**Shoreline Alteration/Dredge and Fill Permit
Modification Application**

SADF-23-01-000-MOD

Applicants: Federico and Danielle Hollander

Modified Site Plan

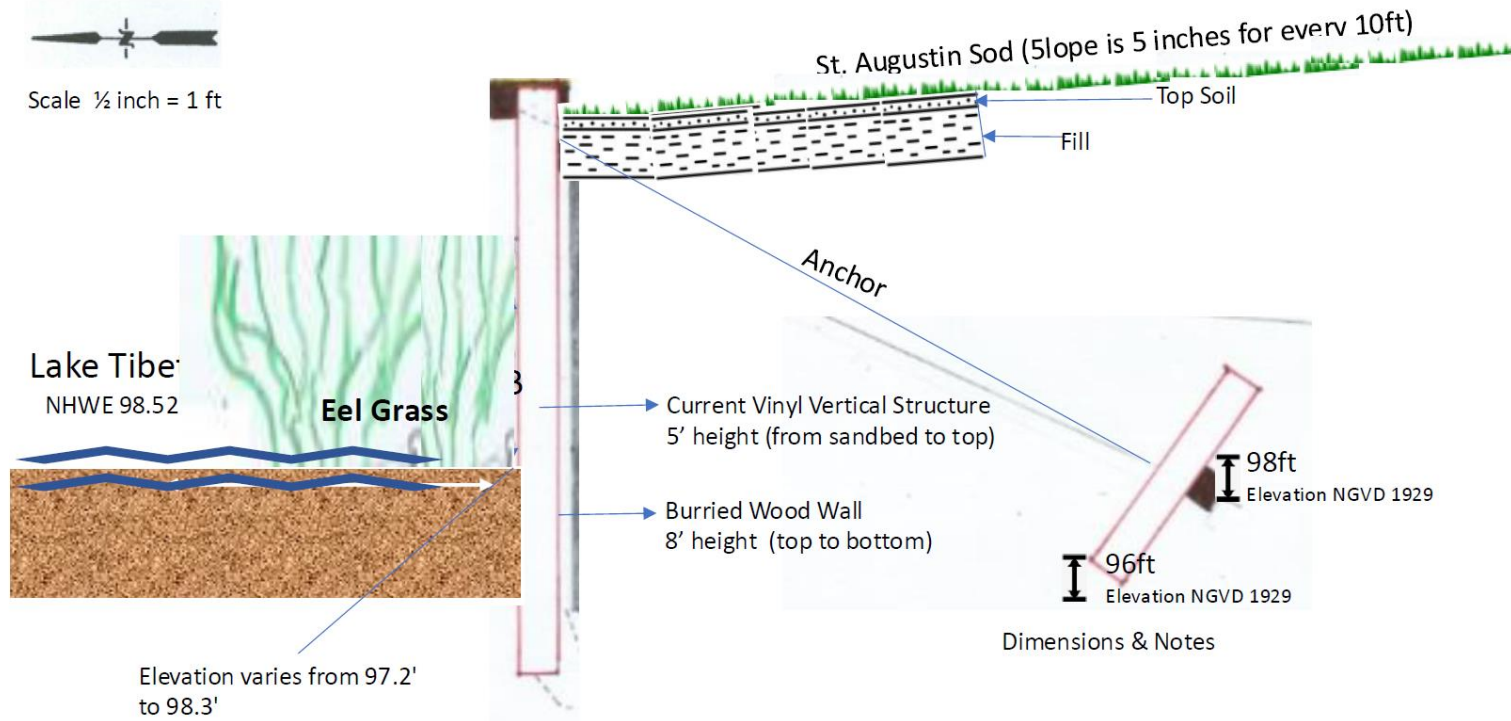
- Wave energy reduction factors:
 - Undulating corrugated geometry of the wall panels
 - Flexibility of the vinyl material
- Anticipated effects include deflected and reduced incoming wave energy, similar to riprap.

I am writing regarding your question as to synthetic sheet pile's ability to reduce wave energy. In my experience, low level waves see a significant reduction in energy/force because of two factors with the sheet pile: the geometry of the sheeting and its base material.

The Army Corp of Engineers Shore Protection Manual (ACOE SPM) recommends that for flat surfaces i.e. flat concrete faces, that the wave reflection coefficient remain at 1. This basically means that the wave is fully reflected out as it impacts against the vertical structure. If we look at just a small area of a flat concrete bulkhead under wave action, it will appear that the wave in that area is moving in a vertical path, back and forth. The more energy put into this system the better chance of the vertical motion affecting the toe of the wall. The standard configuration for the sheet pile is an undulating corrugation. This geometry acts to redirect a portion of the incoming wave in a transverse direction, side to side. The redirection puts it in conflict with the subsequent incoming waves thereby reducing the energy of the direct hit wave. The ACOE SPM notes that lower values for the reflection coefficient may be used provided there is something to the wall's geometry that disrupts a clean reflection. In our case it would be the angle of the sheet's web. In these cases, the SPM will allow for down to 0.9 for the coefficient, like with rip rap.

In terms of energy dissipation, stiffness is not better. The stiffer a material is the more likely you would be to get a full reflection of the wave. The vinyl and composite sheet pile are considered flexible walls in terms of design where concrete and steel would be fixed. Comparing vinyl to steel and concrete you get an order of magnitude more flexibility out of the vinyl sheeting. What this ultimately means is that the synthetic sheets deflect and reduce the incoming energy of a wave and reflect only a portion of the energy.

- **By altering the contour of the lakeshore, vertical seawalls can:**
 - Reduce biodiversity by removing shoreline habitat that provides refuge from predators and foraging area for fish, birds, amphibians, and macroinvertebrates.
 - Affect the natural movement of sand and sediment during storm events, which can lead to erosion in areas not anticipated.
- **Seawalls with riprap and plantings can simulate natural shoreline habitat conditions for foraging and refuge.**
- **Riprap can assist in absorbing wave energy, and plantings assist in nutrient pollutant uptake.**
- **Riprap and planting criteria are summarized in EPD Work Instruction EPD-WI-2000-25, which is used to guide the review of all SADF permit applications involving proposed seawalls or other shoreline hardening projects.**

- Pursuant to Orange County Code, Chapter 33, Article IV, EPD has evaluated the proposed SADF Permit Modification application and required documents and has made a finding that the request is inconsistent with Section 33-129 and EPD-WI-2000-25.

Proposed Site Plan

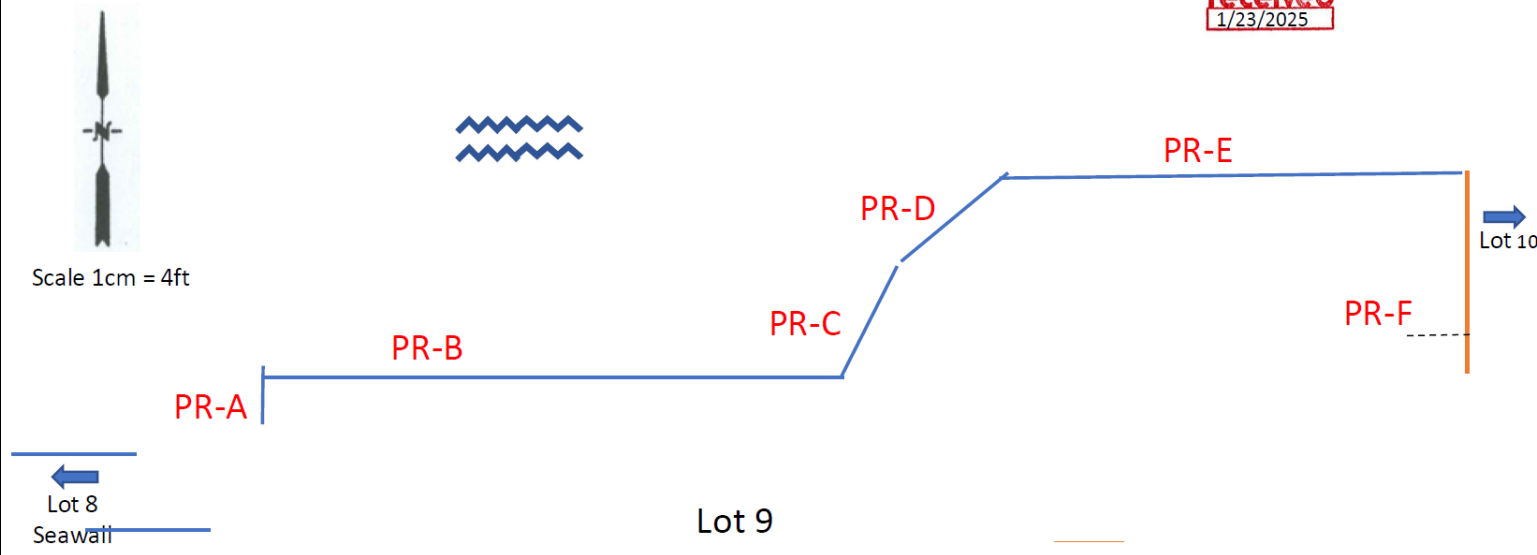
Section	Length	Area of Plantings
A	2.08ft	No
B	55.14ft	Yes
C	8.38ft	Yes
D	20.00ft	No
E	26.66	No
F	20.00ft	No
